MCPB
Item # 6
Date: 12/22/05

SUBJECT: **Development Plan Amendment No: 05-02: Commerce Bancorp, Inc.** Request for amendment of the development plan approved in Local Map Amendment G-540, to the C-T zone of Lots 7, and 23 to allow a construction of a bank facility on 0.90 acre of land consisting of three record lots, Lots 7, 22 and 23, Block H, Kensington View Subdivision located at 2907 and 2909 University Boulevard and 11107 Valley View Drive, Kensington, Maryland.

RECOMMENDATION: **Development Plan Amendment (DPA) No: 05-02**

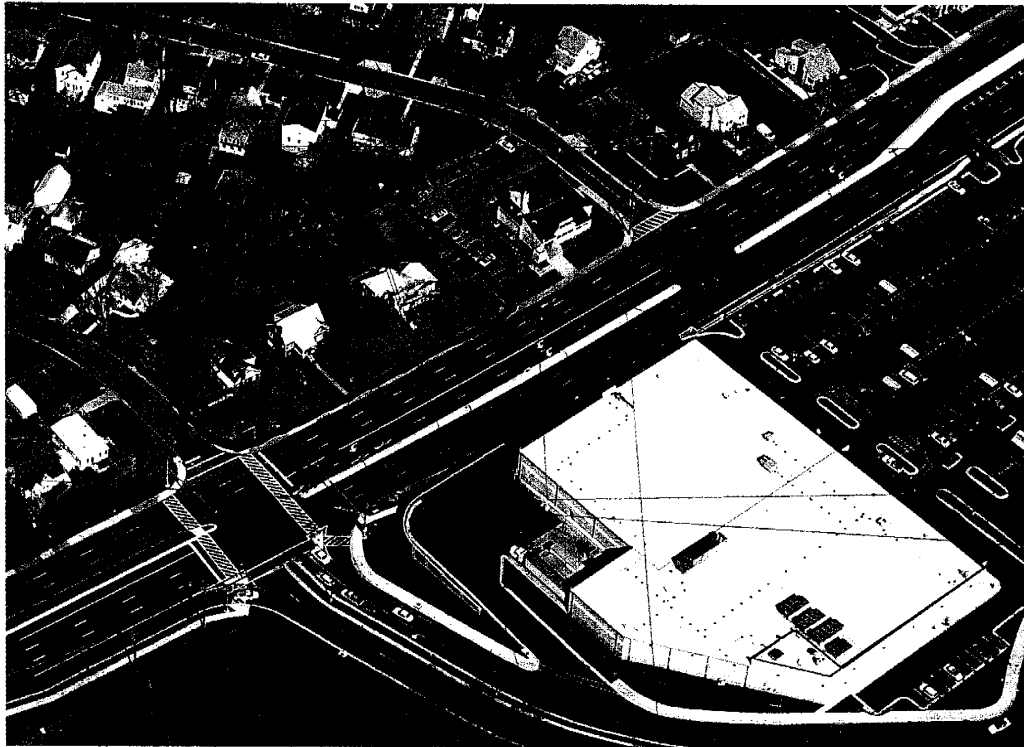
As shown above, the proposed development conforms to all applicable current development standards of the C-T Zone. However, staff has some

concerns regarding the adequacy of the setback from the adjoining residential properties to the north. The building (the canopy over the drive-through-lanes) is set back 18.9 feet from the property line and the drive through-lanes, and the western driveway access are located 13.6 feet from the property line. The proposal provides for landscaping and a six-foot-high board on board fence along the property line. However, given the nature of the use and its location adjacent residential development, a much wider setback and a deeper landscape buffer would be needed to screen the residential properties from potential noise and fume impacts. The community has voiced a legitimate concern regarding fume and noise impacts from vehicles using the three drive-through lanes. Their concern merits serious consideration and requires mitigating measures above and beyond what is proposed by the subject proposal.
